**RE: NATIONAL CONSTRUCTION CODE (NCC) REVIEW 2019**  
**11-17 WILMETTE PLACE MONA VALE NSW 2103**  
**- BCA COMPLIANCE AND DISABLED ACCESS**

## 1.2. Document Control

Figure 5: Location of proposed fire wall for compartmentation (2 options)

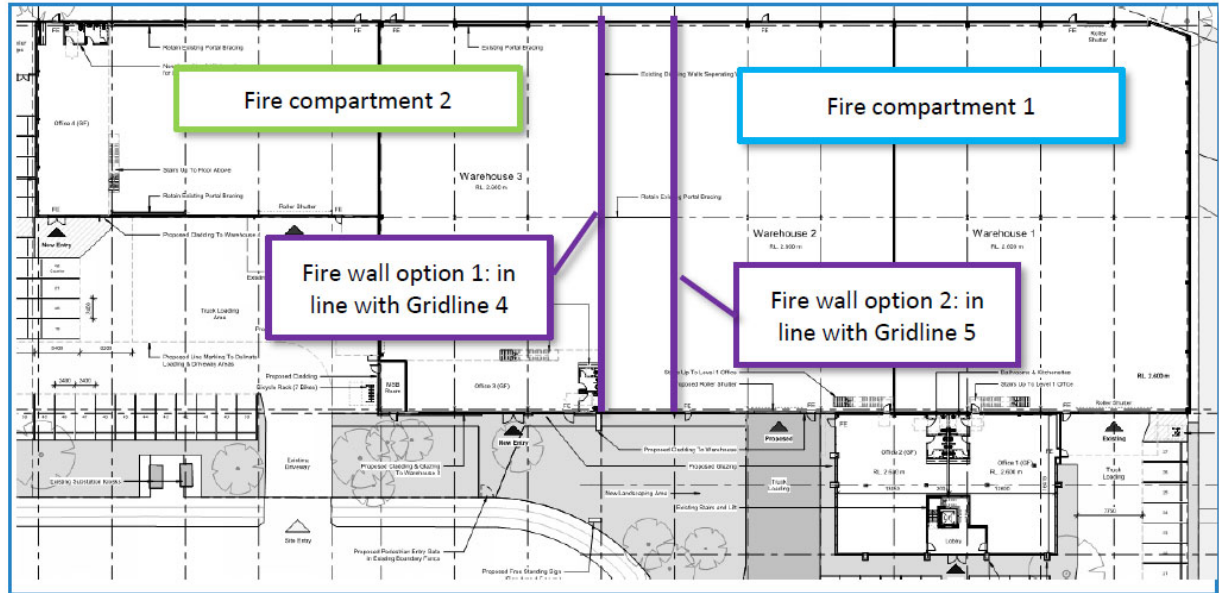
As shown above, there is only one instance of exceeding the DtS limit for fire compartment, i.e., the volume of Fire Compartment 1, being 33,542 m<sup>3</sup>, exceeding the pro-rata DtS limit (31,606 m<sup>3</sup>). This is addressed as a Performance Solution in this Report.

**Fire wall at Gridline 4**

- Fire compartment 1:
  - Area: Warehouse: 3,250 m<sup>2</sup>, Office: 880 m<sup>2</sup> [Total: 4,130 m<sup>2</sup>]
  - Volume: Warehouse: 30,550 m<sup>3</sup>, Office: 2,992 m<sup>3</sup> [Total: 33,542 m<sup>3</sup>]
- Fire compartment 2:
  - Area: Warehouse: 1,822 m<sup>2</sup>, Office: 696 m<sup>2</sup> [Total: 2,518 m<sup>2</sup>]
  - Volume: Warehouse: 17,126.8 m<sup>3</sup>, Office: 2,366.4 m<sup>3</sup> [Total: 19,493.2 m<sup>3</sup>]

**Fire wall at Gridline 5**

- Fire compartment 1:
  - Area: Warehouse: 2,850 m<sup>2</sup>, Office: 880 m<sup>2</sup> [Total: 3,730 m<sup>2</sup>]
  - Volume: Warehouse: 26,790 m<sup>3</sup>, Office: 2,992 m<sup>3</sup> [Total: 29,782 m<sup>3</sup>]
- Fire compartment 2:
  - Area: Warehouse: 2,222 m<sup>2</sup>, Office: 696 m<sup>2</sup> [Total: 2,918 m<sup>2</sup>]
  - Volume: Warehouse: 24,646.8 m<sup>3</sup>, Office: 2,366.4 m<sup>3</sup> [Total: 27,013.2 m<sup>3</sup>]

Note the ceiling height for the warehouse varies from 8.4 m at the eaves to 10.4 m at the ridge. For the purpose of the assessment, an average height of 9.4 m average is taken. The ceiling height for the office area is 3.4 m.

### 3.2.1. Clause D1.4 – Exit travel distance

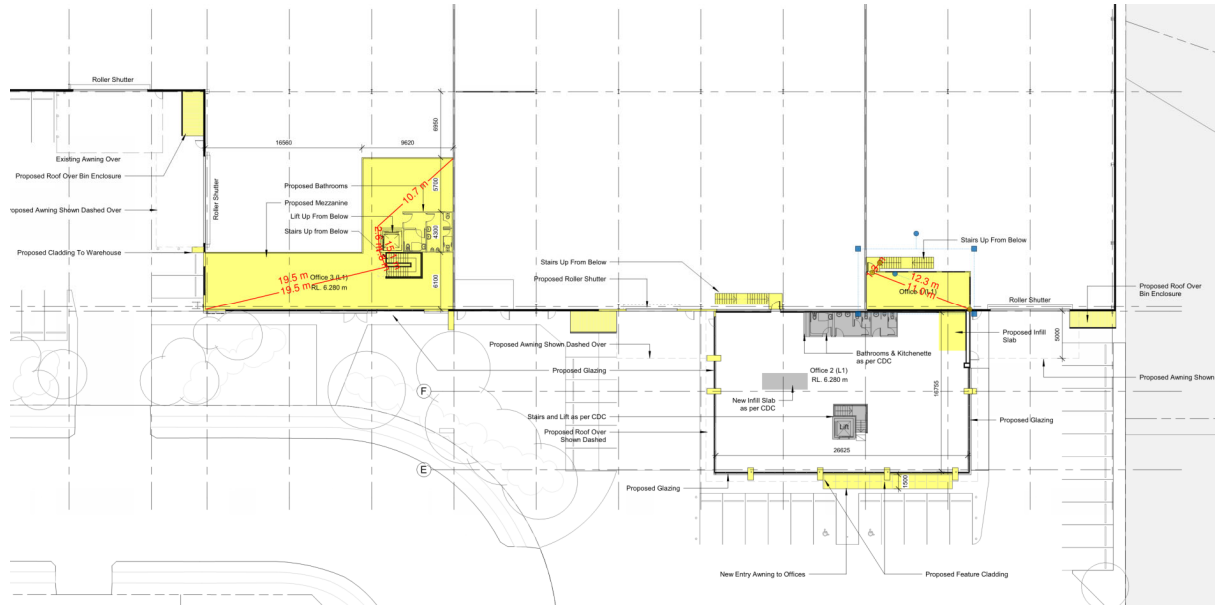
Ground Floor – Complies with DTS Provisions

**Complies via DTS provisions.**

**First Floor – Complies with DTS Provisions**  
*Complies via DTS provisions.*

### Warehouse / Office 1:

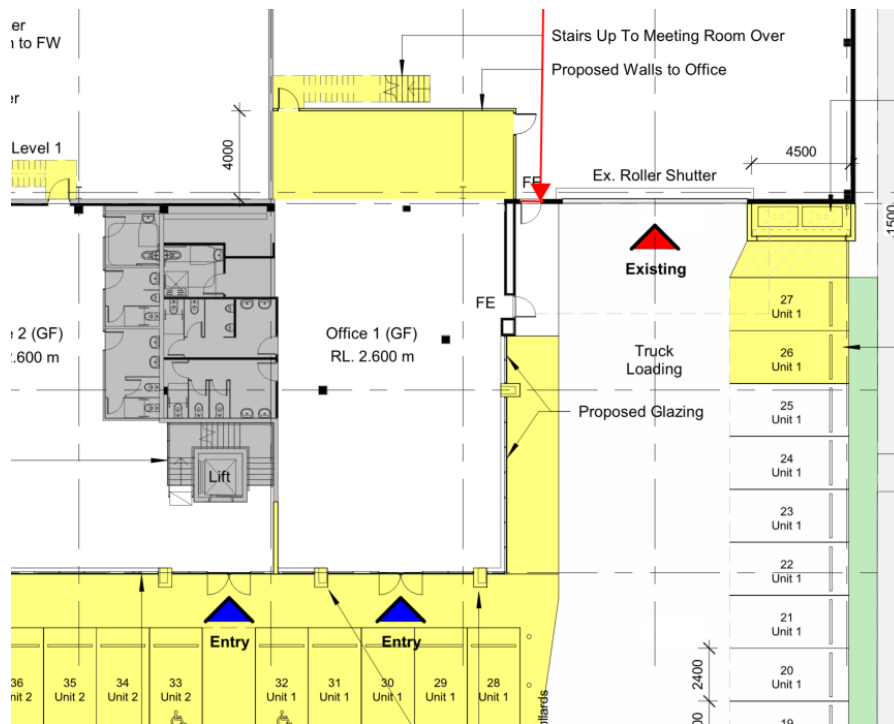
**Ground floor Offices Levels:** Currently the following sanitary facilities are provided allowing for:

PROVIDED	POPULATION	CLOSET PANS		AMBULANT	URINALS		WASHBASINS	
MALE		2*1=3	60	1	2	50	2*1=3	90
FEMALE		3*1=4	50	1	N/A		2*1=3	90
*ACCESSIBLE LH		1			-		1

**Maximum Males = 50 Maximum Females = 50**

**First floor Offices Levels:** Currently the following sanitary facilities are provided allowing for:

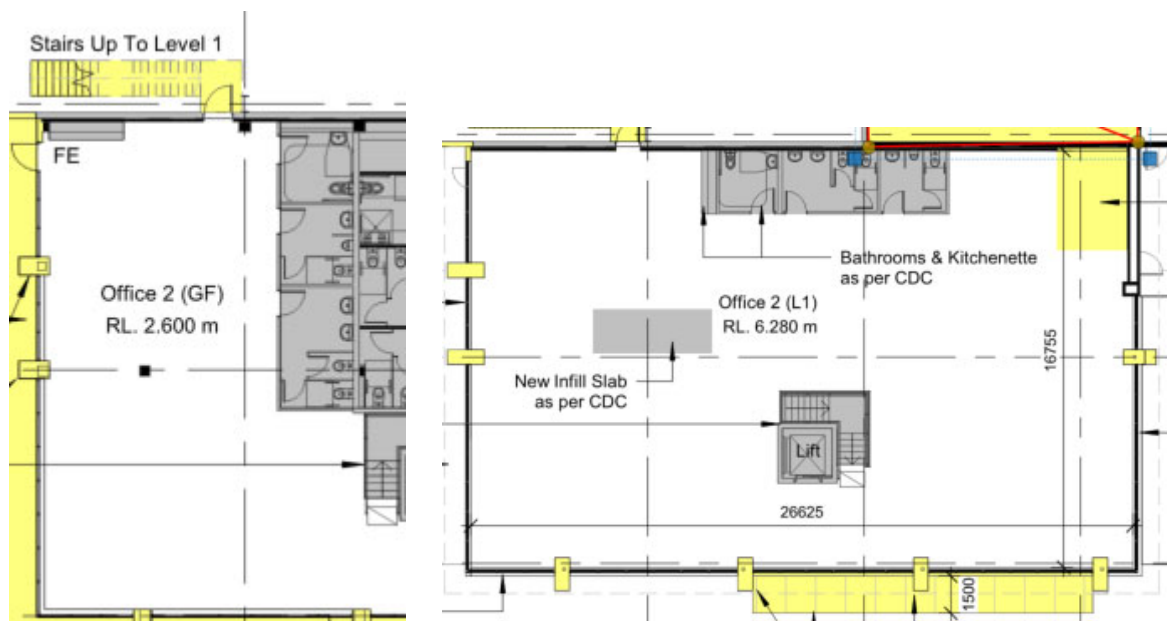
PROVIDED	POPULATION	CLOSET PANS		AMBULANT	URINALS		WASHBASINS	
	MALE	1*1=2	40	1	1	25	1*1=3	60
	FEMALE	2*1=3	45	1	N/A		2*1=3	90
	*ACCESSIBLE RH	1		-	-		1

**Maximum Males = 50    Maximum Females = 90**

**First floor Offices Levels:** Currently the following sanitary facilities are provided allowing for:

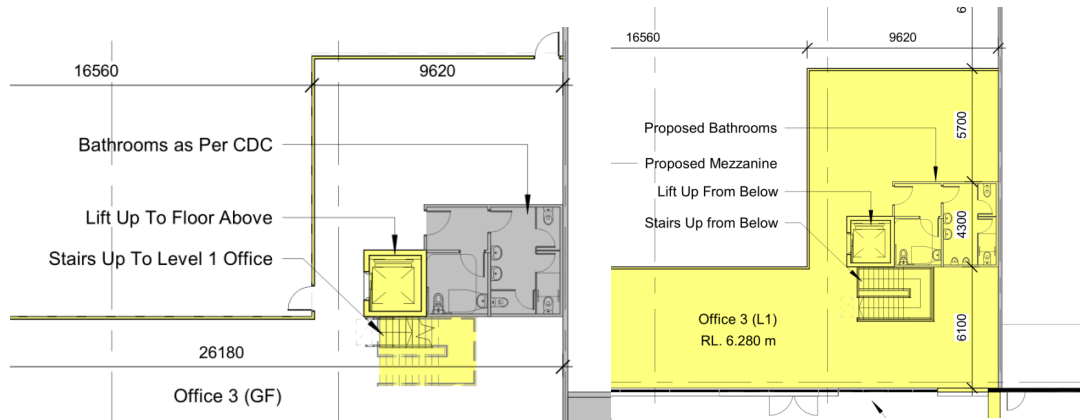
PROVIDED	POPULATION	CLOSET PANS		AMBULANT	URINALS		WASHBASINS	
	MALE	2*1=3	60	1	2	50	2*1=3	90

**Maximum Males = 50 Maximum Females = 60**
